# LCU: Precedent and Voyager 2 System Monitoring Controls Options changes

eAPB2019 | August 14, 2020

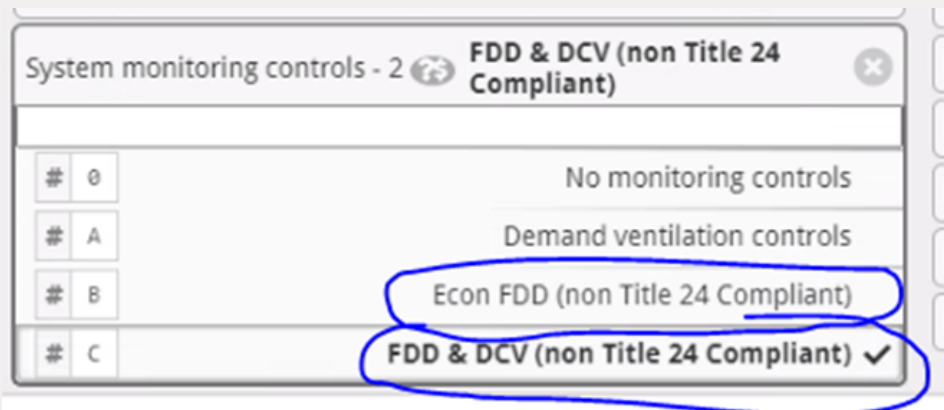
•Options for Econ FDD (non Title 24 compliant) and FDD & DCV (non Title 24 compliant) in digit 26 are discontinued in TOPSS and Job Center.

–To get the TD5 Human Interface, select Advanced Unit Controls in digit 31.

–This change is effective with replication 238.

–FD&D with the TD5 Human Interface is not T24 compliant. It may satisfy AHRAE 90.1 or IECC 2015 if the TD5 is remotely located inside the building.

–A BMS or BAYSENS924\* with Bacnet will satisfy FD&D code requirements.

-Going forward, select the Advanced Unit Controls in digit 31.

-LLE in the fresh air selection must be selected when FDD is required.
